SJ58; CROSSRAIL MODIFICATION FRONT SHEET

MODIFICATION No	**SJ58/GEN/M/063**	Page **1** of **2**
INDEX (1) VERSION:	**N/A**	
PLACE:	**Signalling Scheme Plan – Area 6 East of Plumstead Portal**	
DESCRIPTION OF WORK	Updated to CRL comments	
SCHEME PLAN NUMBER:	C620-SIC-R2-DDE-CR001-00005	Rev: FG

Contract: C620-Signalling
Originator: Siemens Rail Automation
Location: Central Sections General
Title:
SIGNALLING SCHEME PLAN
AREA 6
EAST OF PLUMSTEAD PORTAL

MODIFICATION No	**SJ58/GEN/M/073**	Page **1** of **2**
INDEX (1) VERSION:	**N/A**	
PLACE:	**Area 6 Signalling Scheme Plan updates**	
DESCRIPTION OF WORK	Updated to SJ58/CCF/0665	
SCHEME PLAN NUMBER:	N/A	N/A

Title: SIGNALLING SCHEME PLAN
AREA 6
EAST OF PLUMSTEAD PORTAL

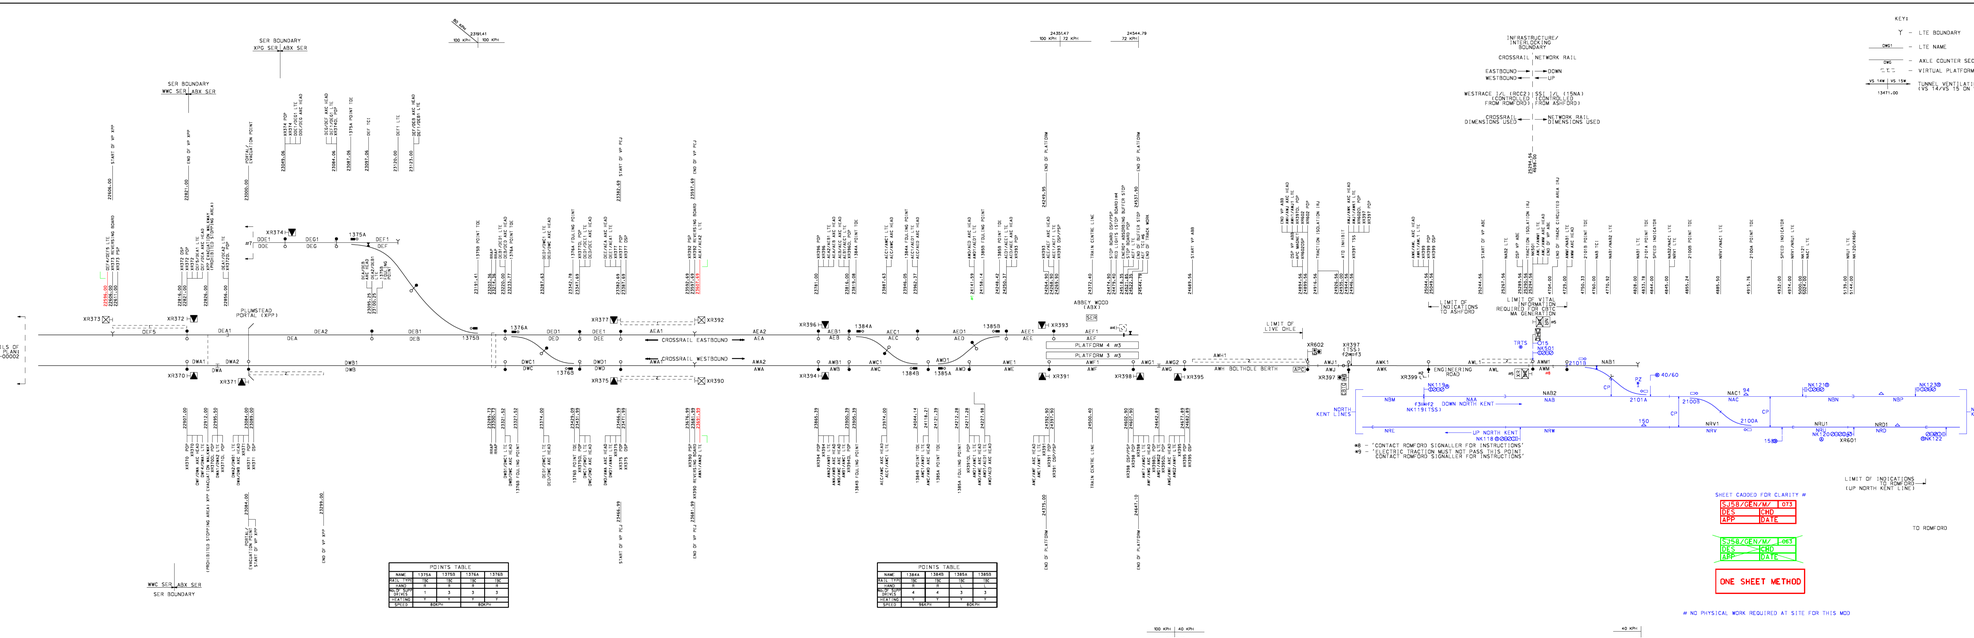
CLEARS CCF: SJ58/CCF/0665, SJ58/CCF/0628

Reference Documents used for this design:		
Previous update reference:	SJ58/GEN/M/063	
Doc. Number	**Document Title**	**Document Version**
SJ58/CCF/0665	AWM EPA Removal	1.0
SJ58/CCF/0628	Reversing Boards at LTE only Boundary	1.0

DESIGN DECISIONS: Use this section to record calculations and other factors relevant to making design decisions.		
ITEM No.	**DETAILS**	**REMARKS**
1.	I have updated the scheme plans to include the previous changes. Along with a records only update to remove a '#1' note.	
2.	Updates have been made to clearCCF/0628, however the CCF states 'DEF4/DEF5', this is incorrect, the letter used is 'O' therefore it should be 'OEF4/OEF5'.	
3.

#8 AWM LTE HAS NO FACILITY FOR AN EPA TO BE APPLIED, SO NO PROTECTION SHOULD BE ASSUMED WHEN UNDERTAKING MAINTENANCE ACTIVITIES IN THIS AREA.
